SUBJECT: NRC STAFF ASSESSMENT OF DUKE ENERGY CAROLINAS,
LLC., OCONEE EXTERNAL FLOODING ISSUE (TAC NOS.
ME4441, ME4442, AND ME4443)

NRC Assessment of Oconee External Flooding Issue

The purpose of this assessment is to verify that the licensee's Case 2 random sunny day failure scenario for the Jocassee Dam and the ONS site provides reasonable assurance for water levels that the site would see if there was a random sunny day failure of the Jocassee Dam. This Case 2 scenario will be the new flooding bases for the site. Results of the hypothetical dam failures provide inputs to surface water flow models used to simulate floodwater levels at the ONS site, specifically the water levels at locations that could have an effect on emergency shutdown capability, particularly, the Safe Shutdown Facility (SSF). The SSF is a partially flood protected structure which houses control systems to shut down the plant. Ground elevation at the base of the SSF is 796.0 ft. msl.

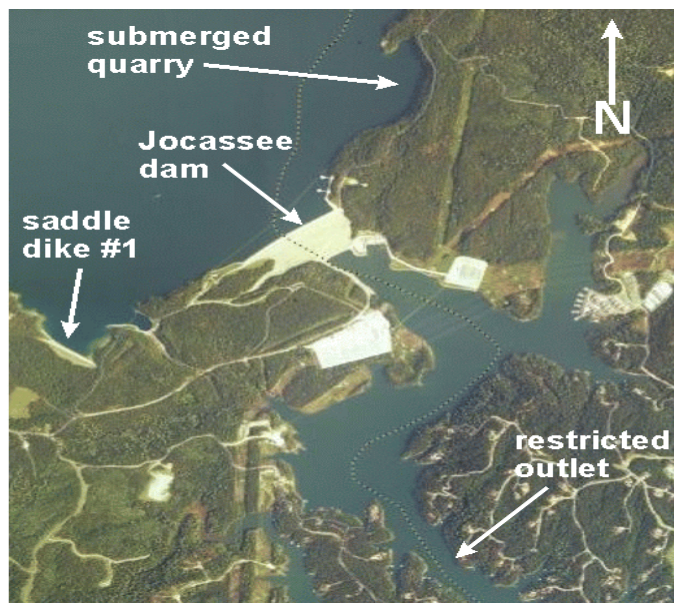
Preliminary results from the licensee presented in October 2009 showed a double peaked elevation hydrograph occurring at the SSF. From the timing of the peaks, it was determined that the first peak was primarily due to overtopping and breaching of the ONS intake canal dike. The second peak appeared to be primarily from the Keowee tailrace with flow from the Keowee Dam failure combined with flow over the site from the West Saddle Dam and the ONS intake dike failure.

At the request of the staff, the licensee further investigated the effects of a more rapid failure of Keowee Dam to produce a greater Keowee tailrace contribution to site flooding. The licensee added 6 more HEC-RAS runs and selected two of the runs (100B and 100F) for more detailed 2-D modeling. HEC-RAS run 100 was used to set the 2-D boundary conditions. The additional HEC-RAS runs evaluated were:

Figure 1: FLOW MODEL SCHEMATIC (Duke, 2009)

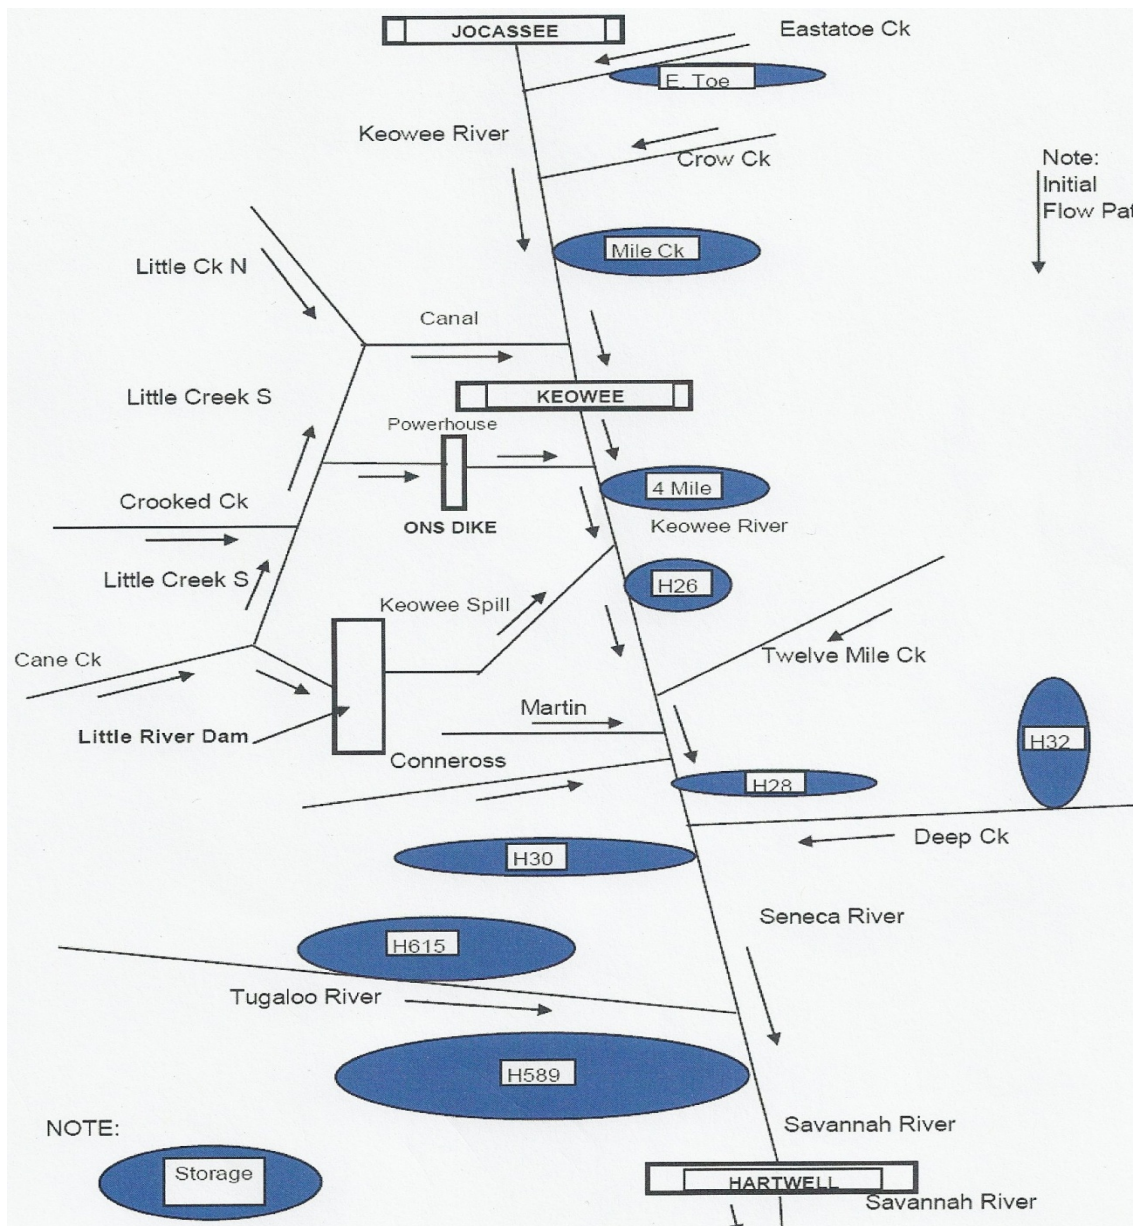
Early in the review, there was concern about the ability of a 1-dimensional model to effectively simulate the flow regime immediately upstream of the canal to the north of the plant (connecting the Keowee River Basin to the Little River Basin) where the downstream velocity vector makes a 90 degree change in direction. Also, the potential for inundation of the site comes from many potential sources and is likely to flow in different directions without channelization. Such overland flow may involve eddy patterns, flow recirculation, and spill over barriers. Alternate wetting and drying of area elements may also be required depending on the overland flow patterns. For these reasons, a two-dimensional model was coupled to the HEC-1 simulations at boundaries, sufficiently remote, where the hydraulic parameters of flow and depth would be relatively unaffected by flow over the site.

Figure 2: TWO-DIMENSIONAL MODEL BOUNDARY DEFINITIONS (Duke, 2010)

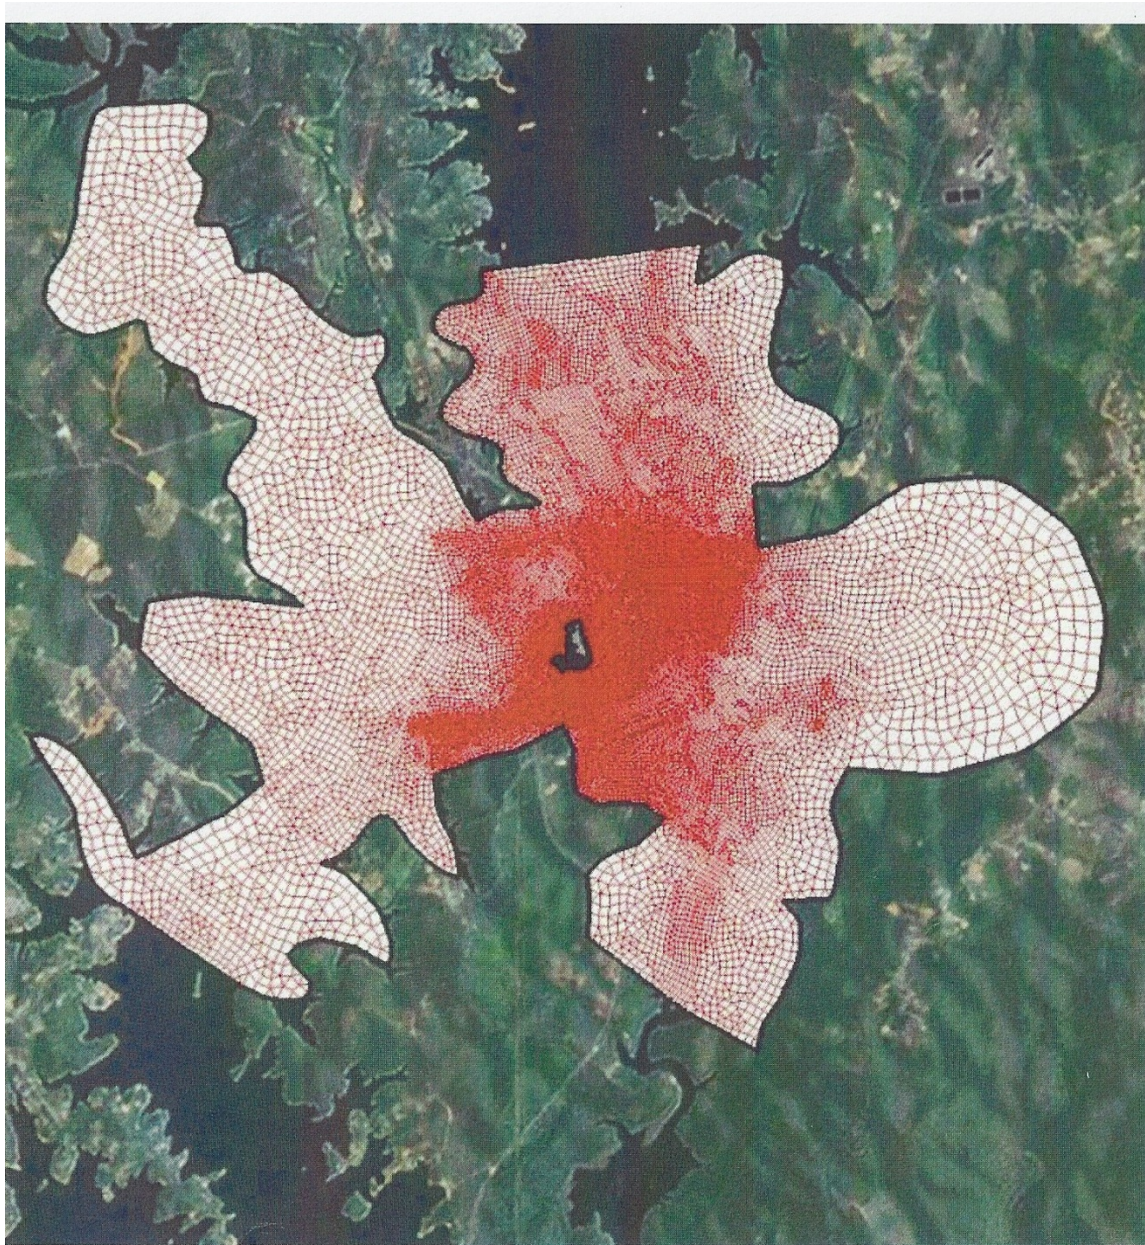
The one dimensional HEC-RAS and two-dimensional SRH-2D models are not dynamically Coupled; and mass and momentum between the two models cannot be conserved. Hence, the potential backflow between the inflow and outflow boundaries cannot be incorporated into the

model. Also, the simulations represent an extreme and unobserved scenario and parameters, such as, roughness coefficients over the site cannot be calibrated, requiring the selection of conservative values. The lack of coupling resulted in higher water levels from the 2-D simulations at the upstream boundaries than from the HEC-RAS runs (Wilson, 2010 and Young, 2009). The peak of the higher values at the upstream boundary after a short dip, as plotted by

Wilson, appeared about 20 minutes later than the peak at Keowee. This indicated a possible reflection of the flood wave at Keowee Dam intensified by the rigid (no backflow) upstream boundary condition. This intensified reflection may have resulted in greater flow through the Keowee tailrace. The ONS peak appeared occur earlier and was probably unaffected, although it was still about a foot higher than the HEC-RAS simulation.

Model runs 100B and 100F were selected for the more detailed 2-D assessment. Evaluation of these runs showed that faster failure times did not increase water depths at the SSF and that the original set of parameters with an updated computational mesh results in the greatest depth at the SSF of 19.5 ft.

When it was confirmed that case 100M (original case) resulted in the highest 2-D water levels, case 100W was formulated to incorporate improvements utilizing new boundary conditions and became the record model run.
